**Subject: Powers Engineering Comments on A.06-08-010 Sunrise Powerlink DEIR**

In the Matter of the Application of San Diego Gas & Electric Company (U 902-E) for a Certificate of Public Convenience and Necessity for the Sunrise Powerlink Transmission Project	Application 06-08-010 (Filed August 4, 2006)
-------------------------------------------------------------------------------------------------------------------------------------------------------------------------------------	-------------------------------------------------

**PHASE II DIRECT TESTIMONY  
OF POWERS ENGINEERING  
ON BEHALF OF BILL POWERS, P.E.**

**Figure 1. California Energy Commission Projection of Impact of Varying Levels of Energy Efficiency (EE) on Electric Energy Consumption by California Utilities – Red Line Represents Achievement of 100% of Cost-Effective EE Measures**

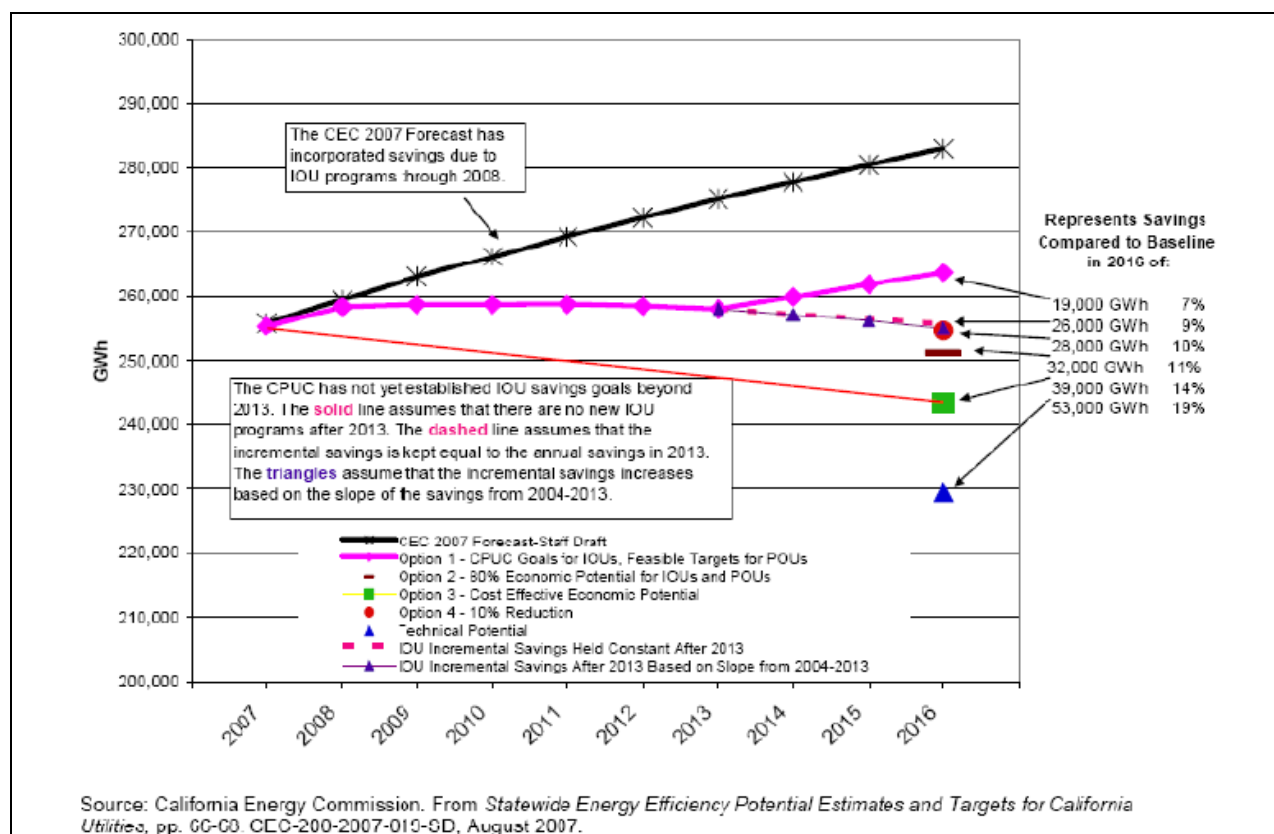
demand decline of approximately 0.5 percent per year over the next decade in SDG&E service territory (See Figure 1 below).

This decline in peak demand would reverse the 482 MW increase in demand by 2016 projected by SDG&E as the reliability justification for the Sunrise Powerlink and convert it into a 280 MW demand decline over the same period. Energy efficiency is the highest priority on the Energy Action Plan loading order. As explained in Attachment B, dozens of cost-effective energy efficiency projects have been carried-out by the City of San Diego with an average absolute reduction of energy use of 20 percent.<sup>21</sup> The DEIR errs by not including 600+ MW of firm on-peak capacity in the form of energy efficiency. This firm on-peak energy efficiency capacity should also be included in the In-Area Renewable Generation alternative.

**Figure 2. 500 kV Interconnection between Sunrise Powerlink and LEAPS lines**

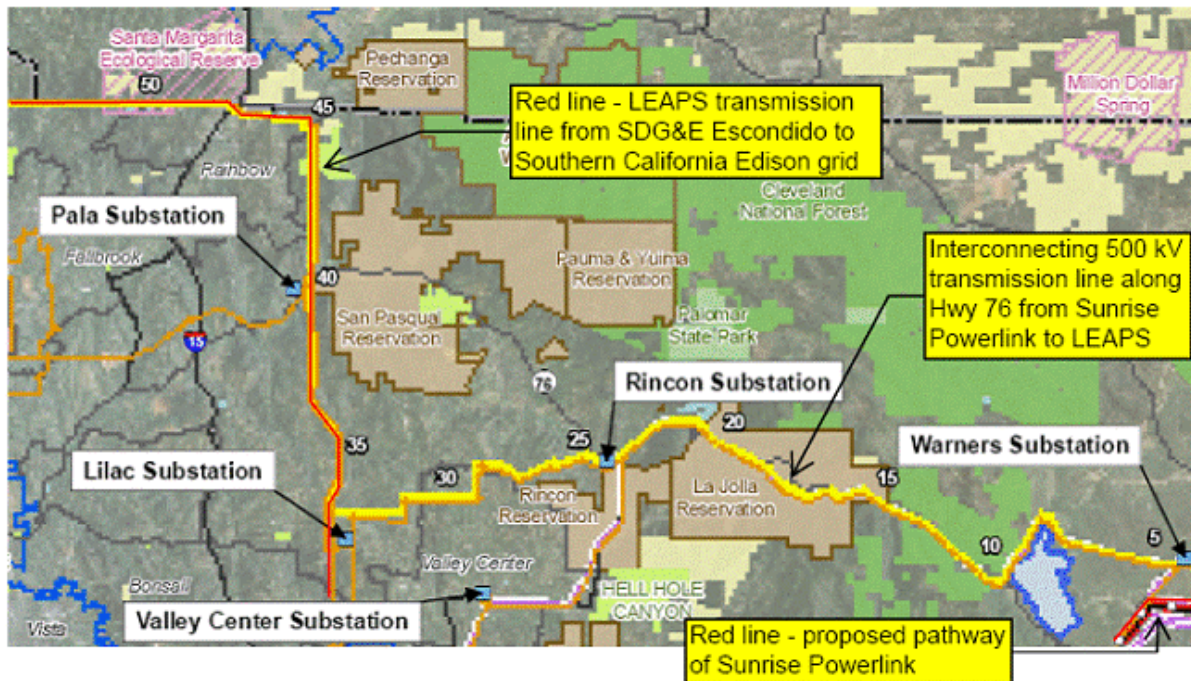
However, the Full Loop described by SDG&E is missing one piece, an interconnection between the Sunrise Powerlink’s Central substation near Lake Henshaw and the LEAPS 500 kV substation on Camp Pendleton’s northern boundary. The Talega-Escondido 230 kV line is a component of the LEAPS transmission project. This existing 230 kV corridor is only about 30 miles from the proposed Central substation of the Sunrise Powerlink. The interconnecting 500 kV line between the Central substation and the LEAPS 500 kV substation will follow the route of the existing Warners-Rincon 69 kV transmission line along Highway 76, then the existing Rincon-Lilac 69 kV transmission line to the Lilac substation north of Escondido. The 500 kV line would then parallel the existing Talega-Escondido 230 kV line about 30 miles to the proposed Pendleton substation on the 500 kV LEAPS transmission line. The portion of the 500 kV interconnection route passing through or by Indian lands along Highway 76 is shown below in Figure 2 (map extracted from Figure B-12b, DEIR, p. B-30, tags added by B. Powers).<sup>39</sup>

The failure of the DEIR to include an environmental analysis of this 500 kV interconnection between the Sunrise Powerlink Central substation and the proposed Pendleton substation on the 500 kV LEAPS transmission line is a critical omission.
